PLANNING NMA

Eton House | Explore
18-24 Paradise Rd, Richmond TW9 1SE

Rev 01

1 Consented vs Proposed Drawings

1.7 Consented - L03 Plan

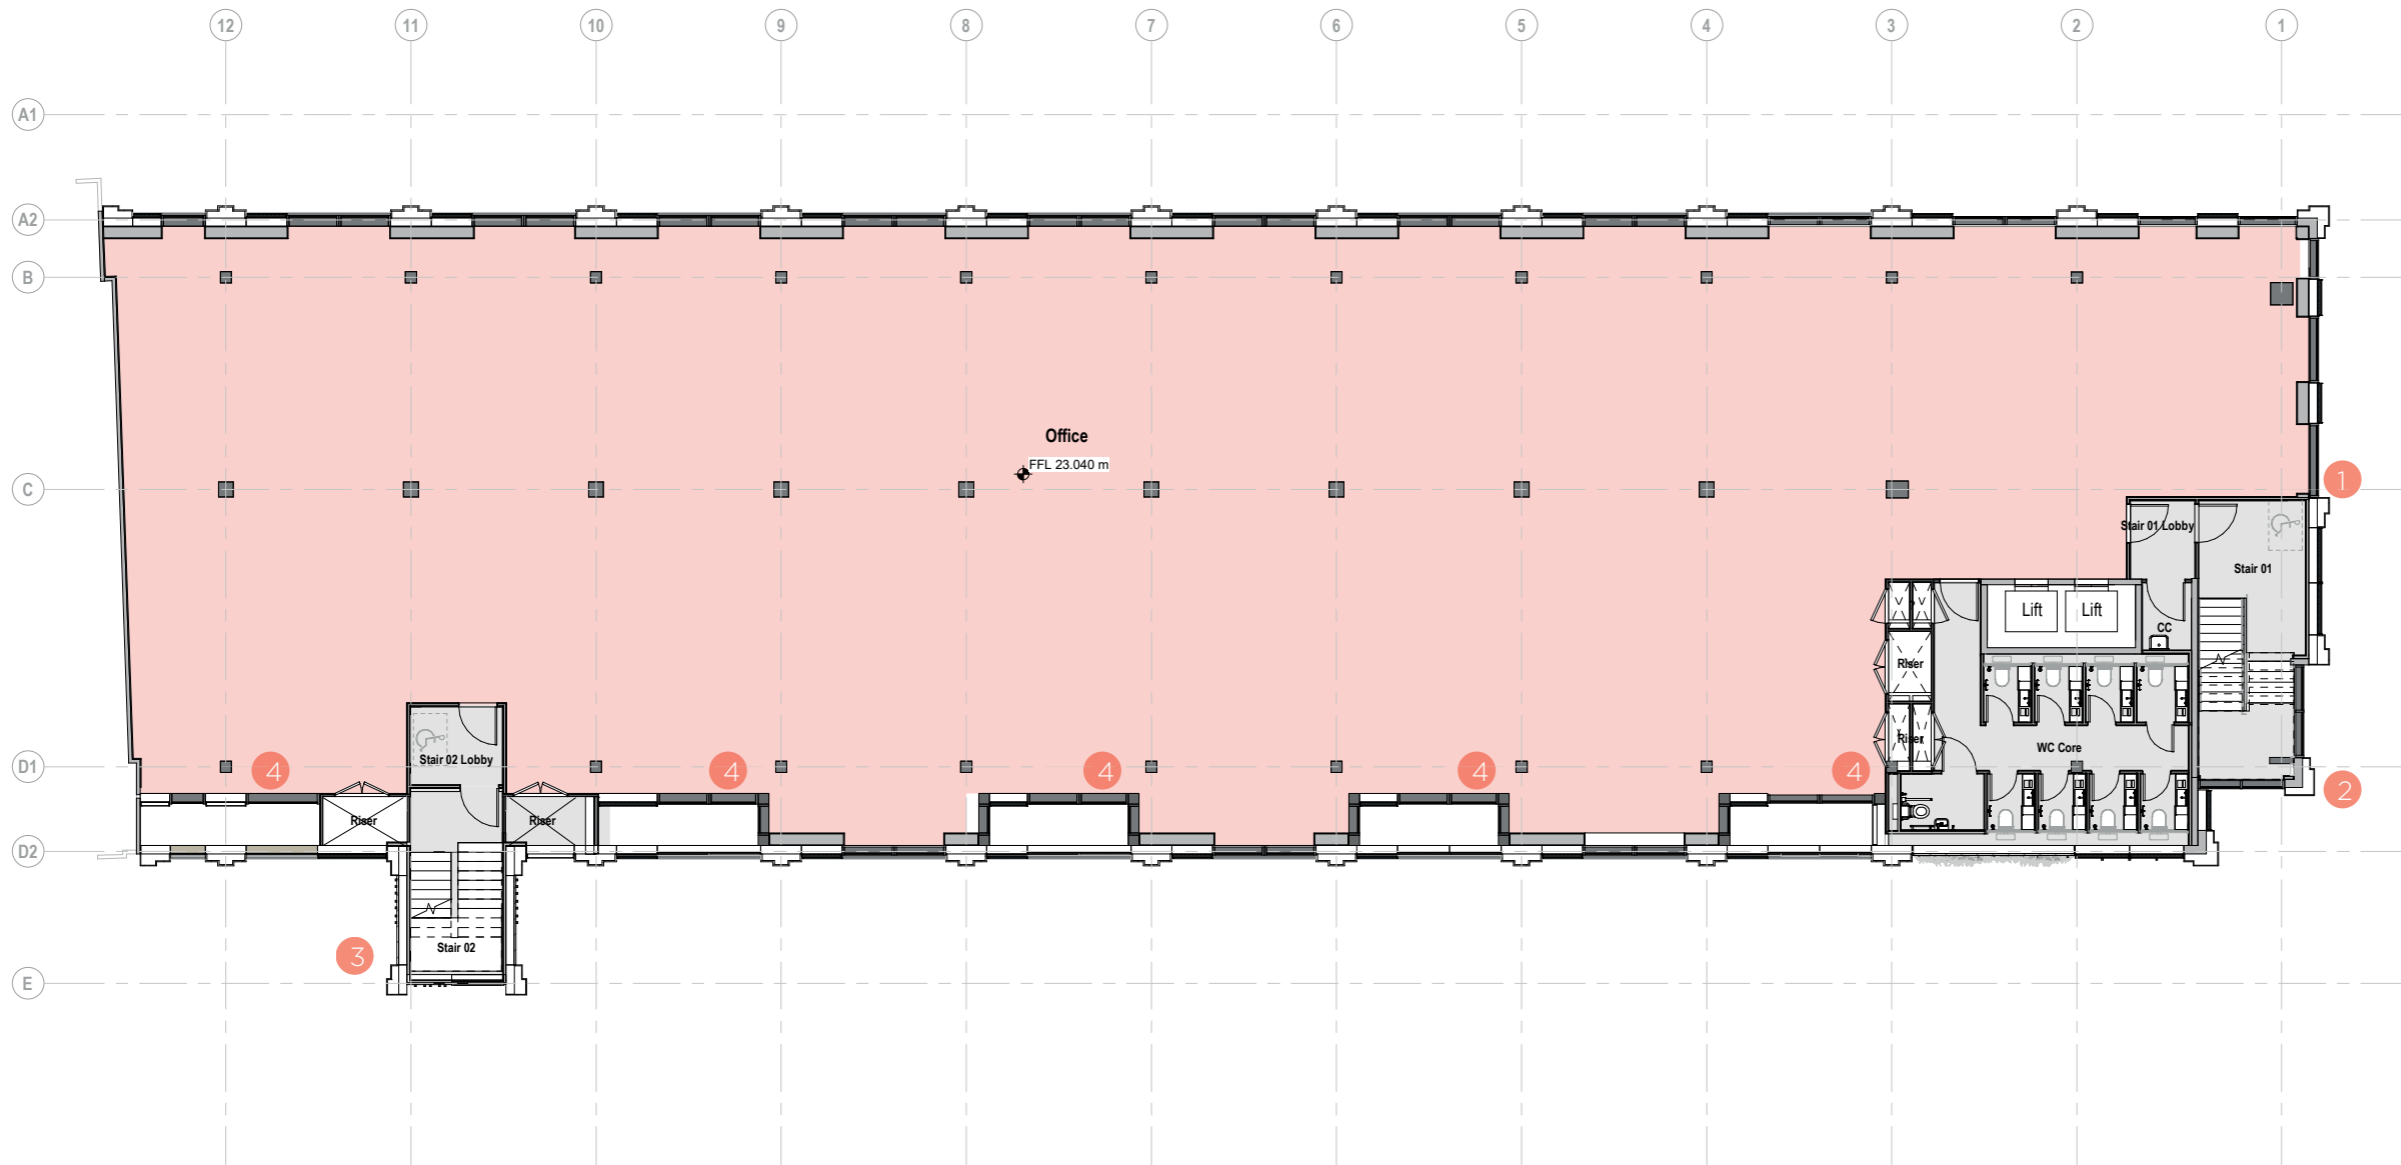
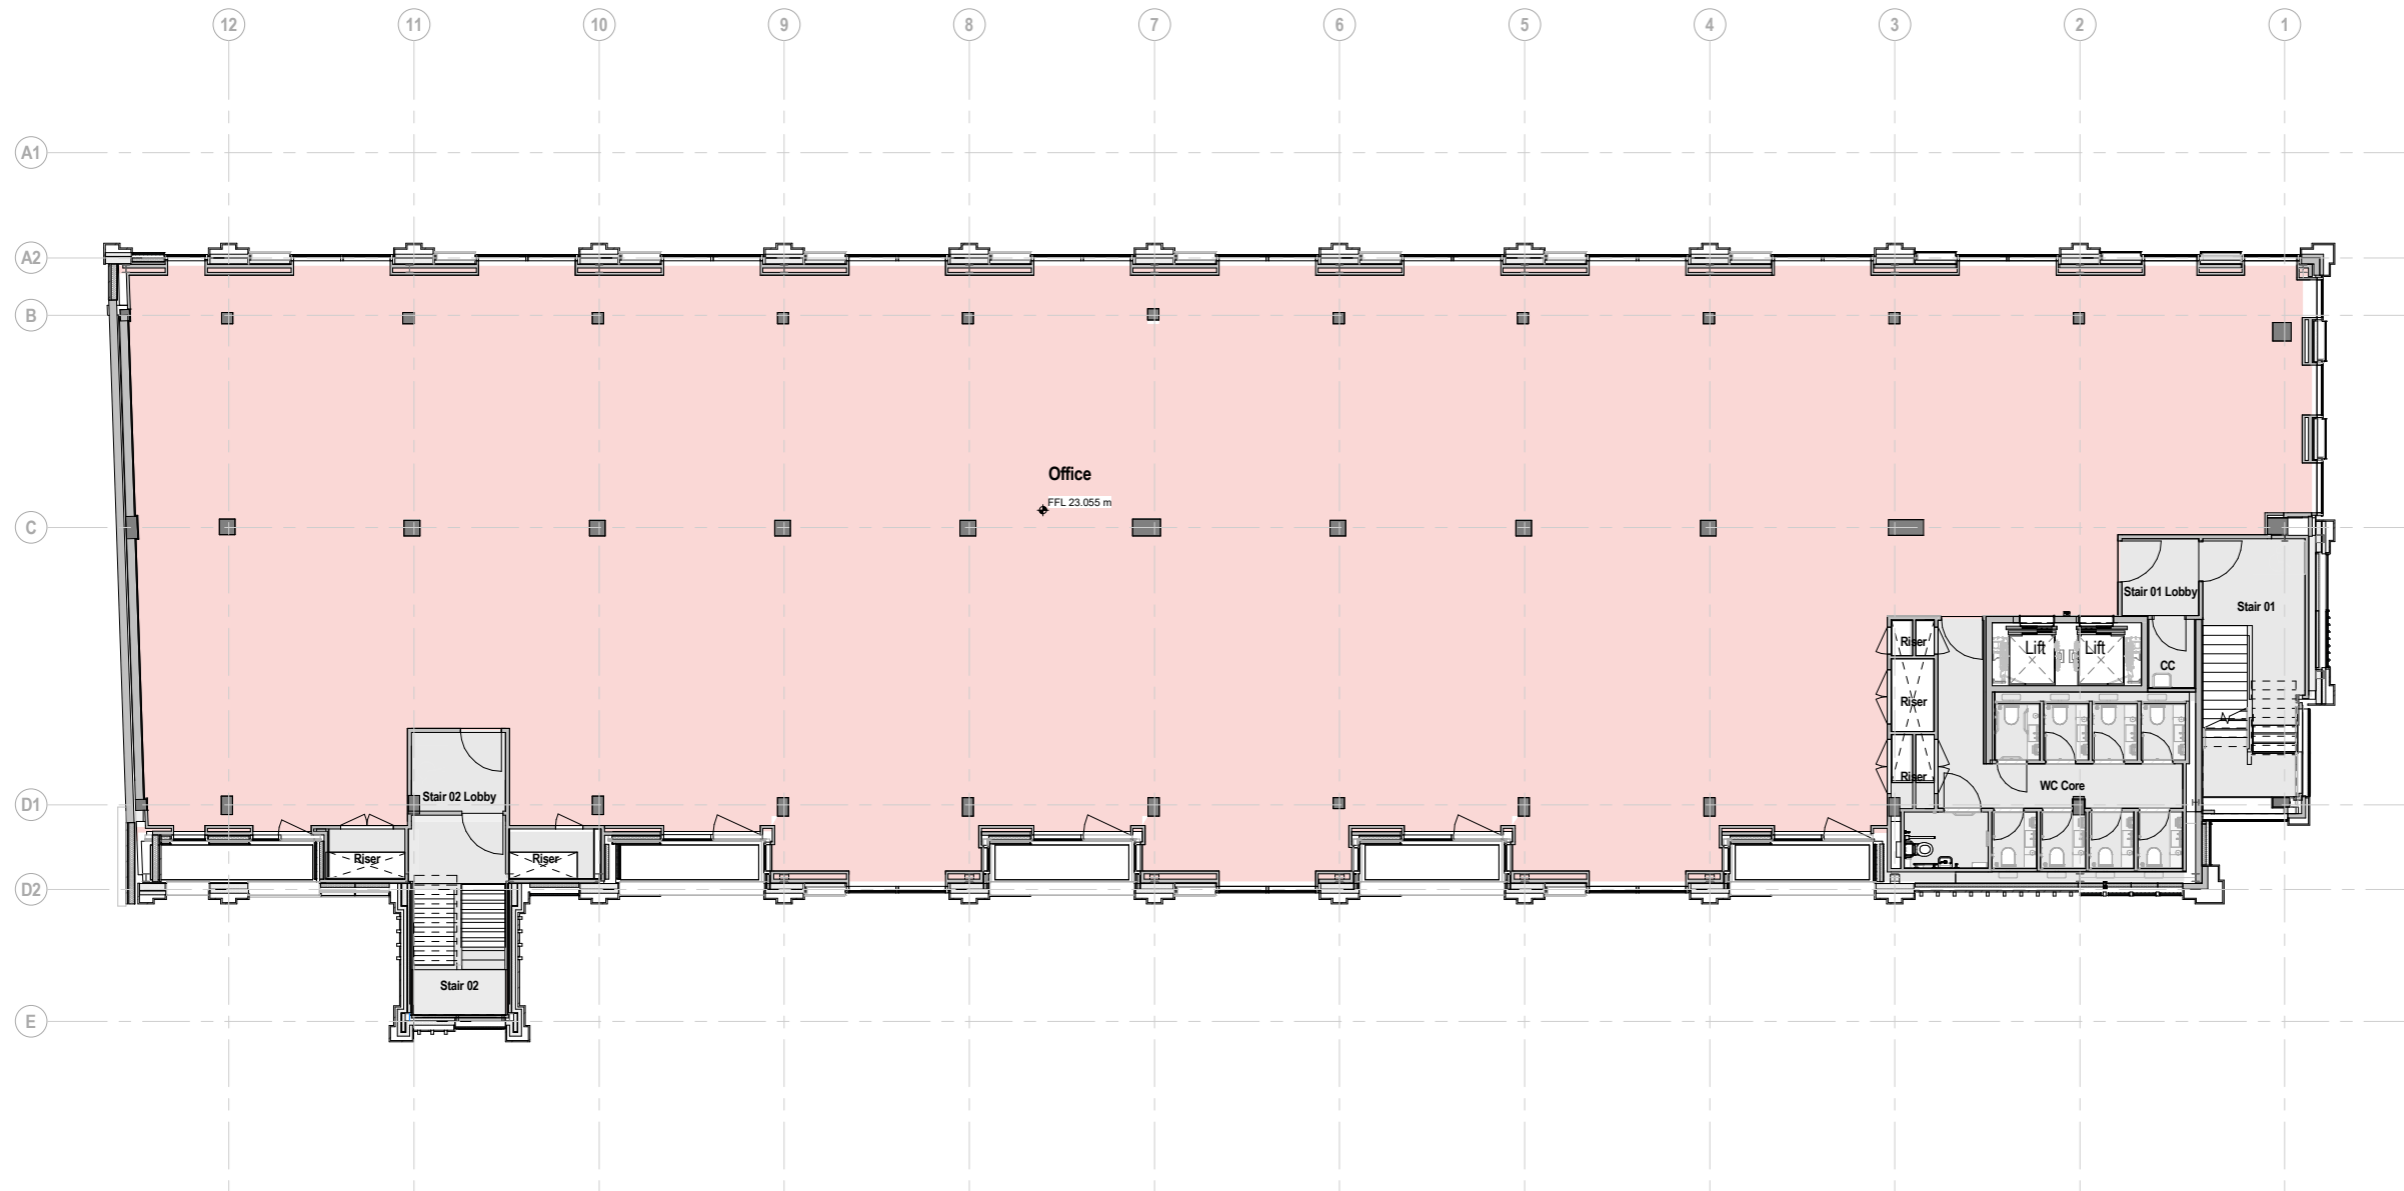
- 1 Marginal adjustment to wall position to suit existing structural discovered during detailed survey
- 2 Corner pier adjusted to avoid cross past boundary line
- 3 Number of fins reduced due to buildability constraints and to appear less cluttered.
- 4 Glazed panel now a glazed door for maintenance purposes

1.9 Consented - L04 Plan

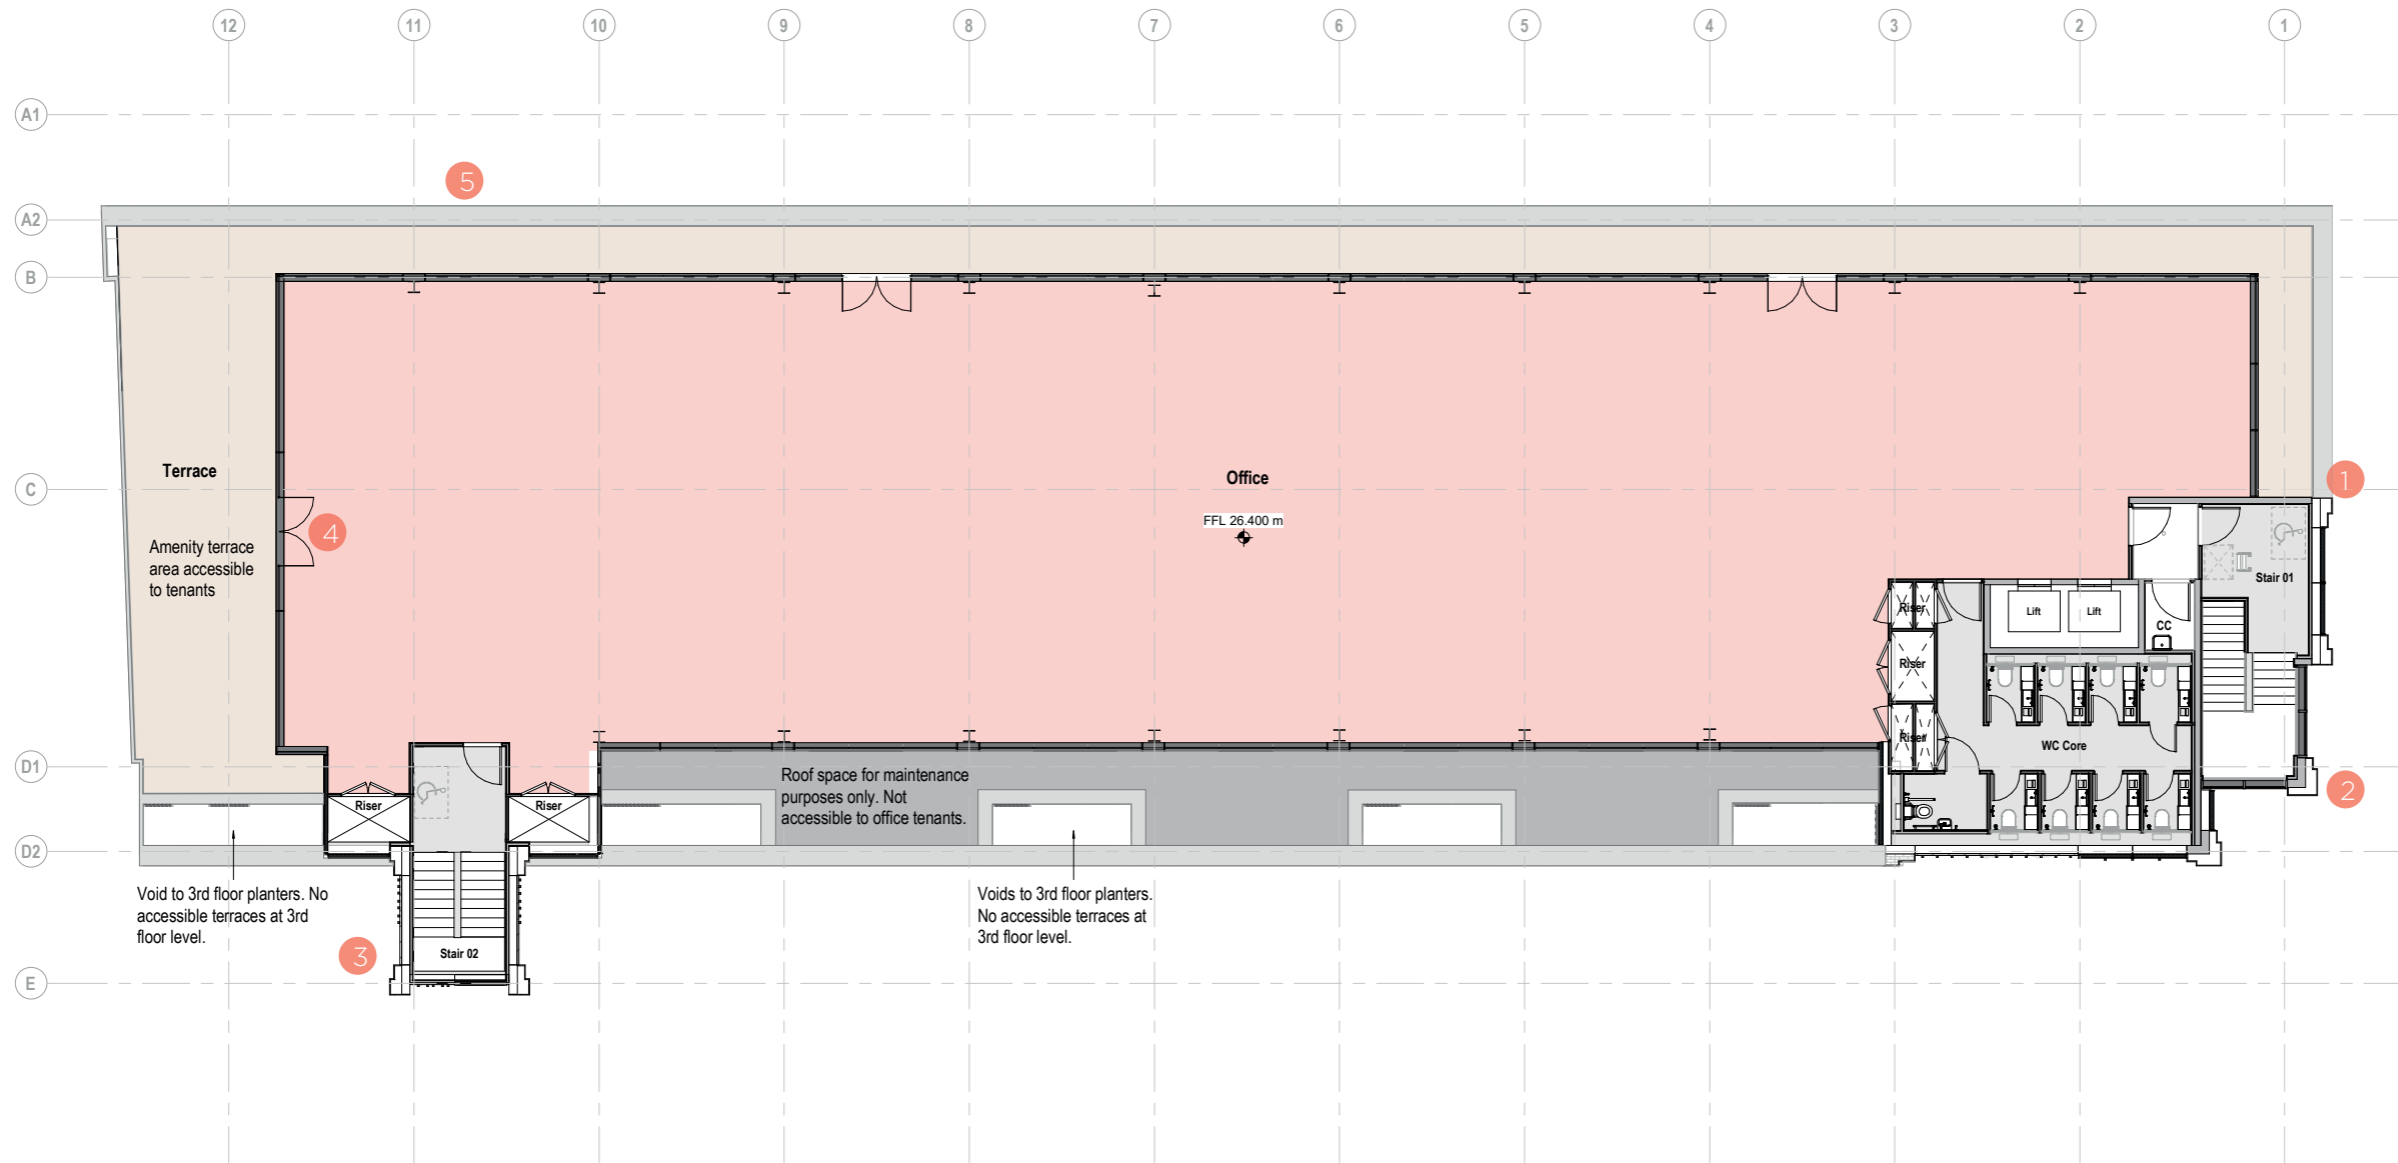
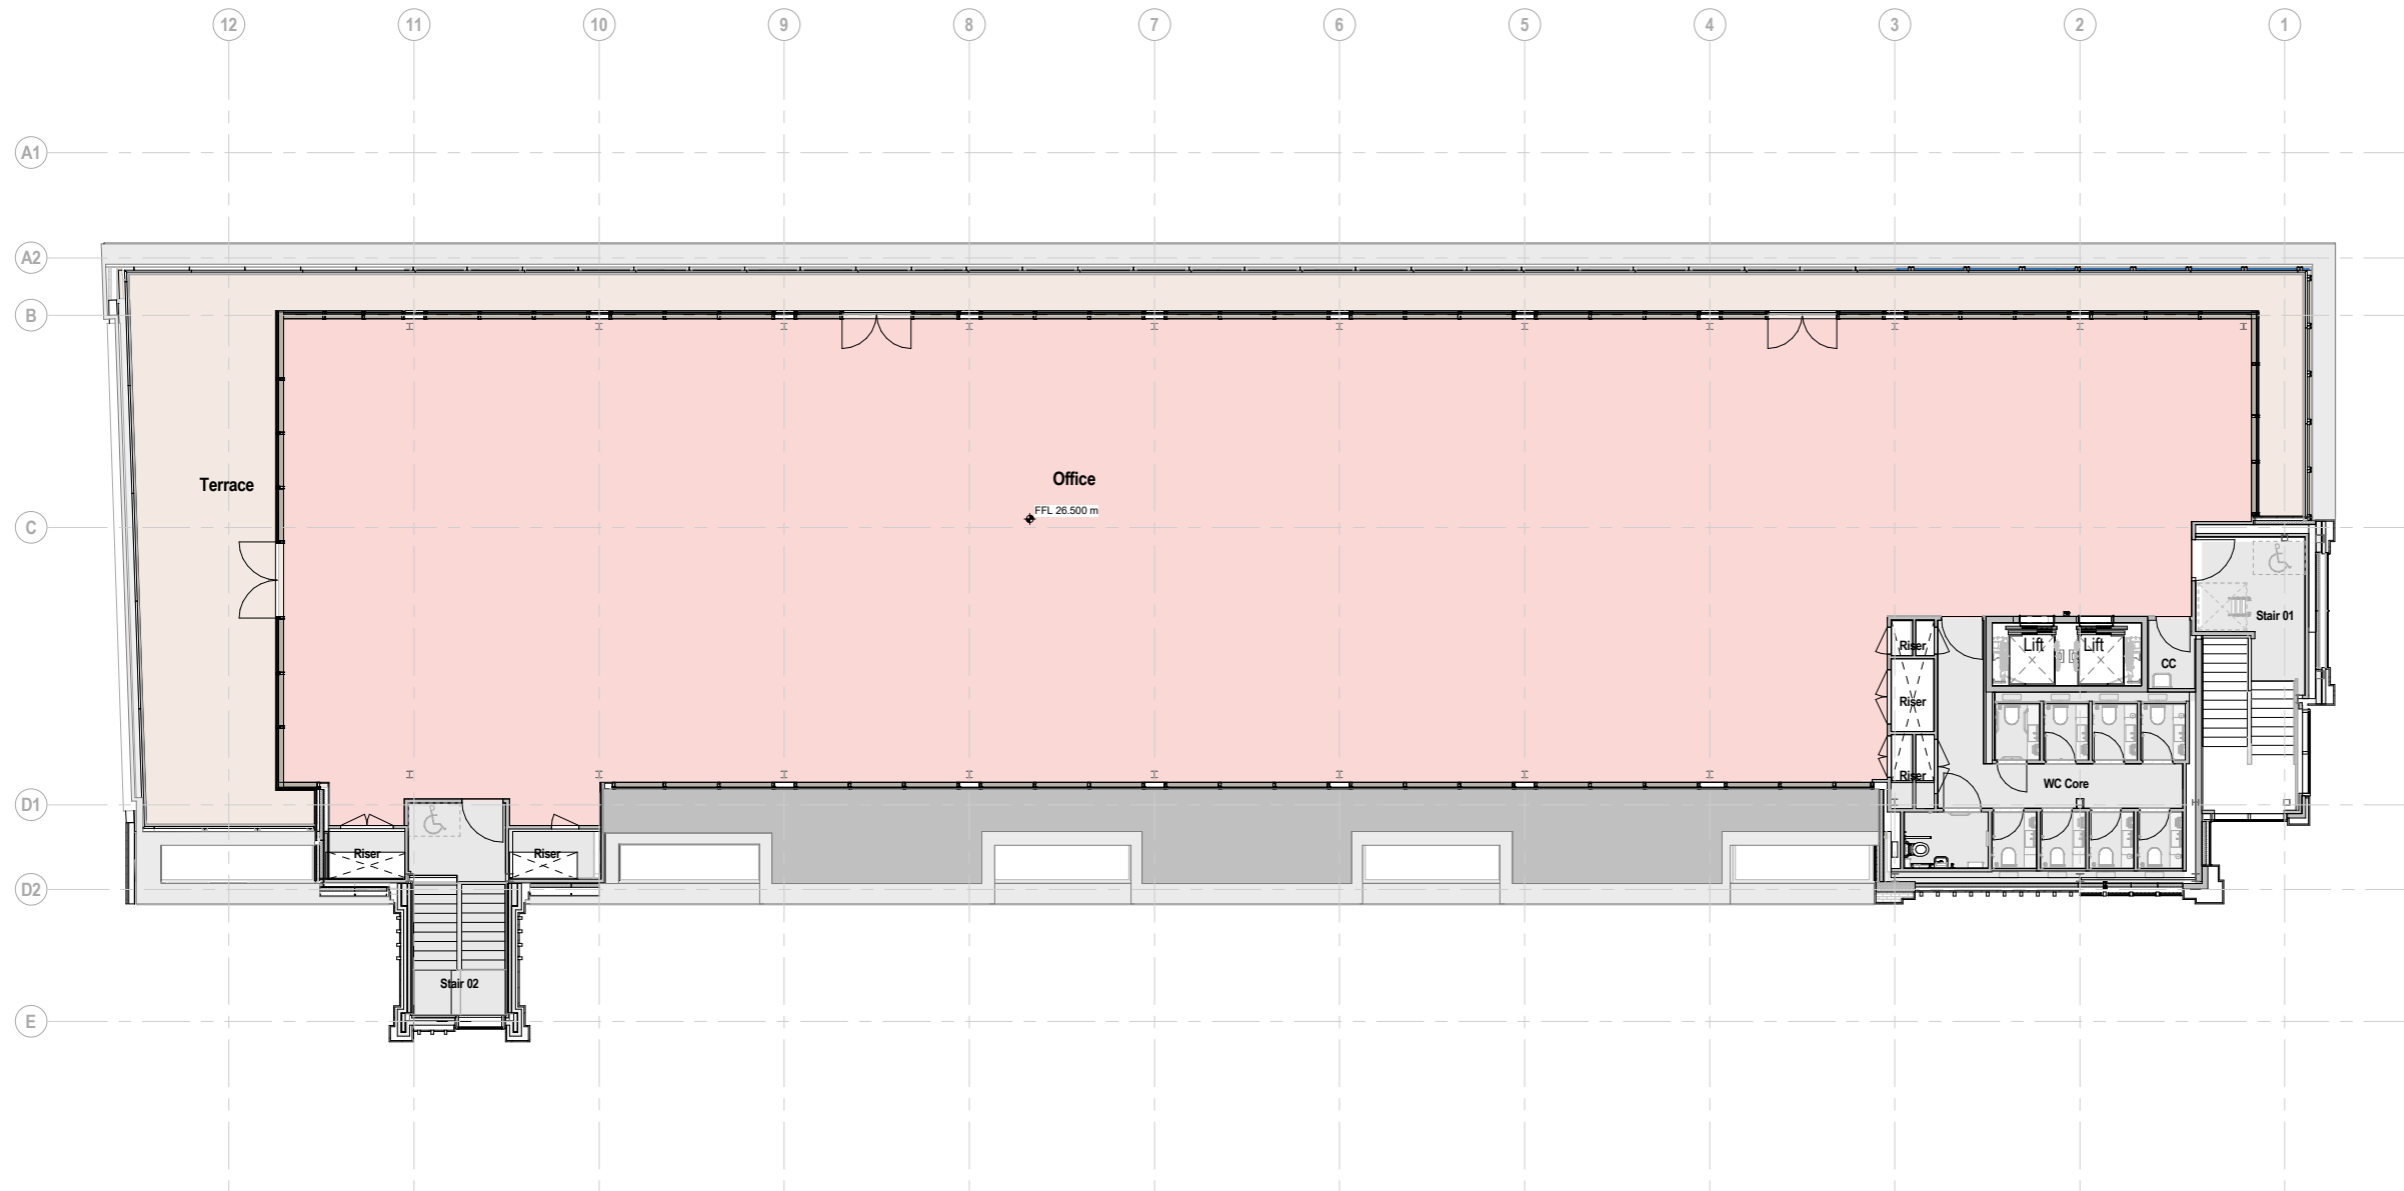
- 1 Marginal adjustment to wall position to suit existing structural discovered during detailed survey
- 2 Corner pier adjusted to avoid cross past boundary line
- 3 Number of fins reduced due to buildability constraints and to appear less cluttered.
- 4 Door flipped to open outwards following detailed occupancy calculations for terrace to allow for improved accessible access to terrace
- 5 Balustrade was not clearly shown on plan at planning stage
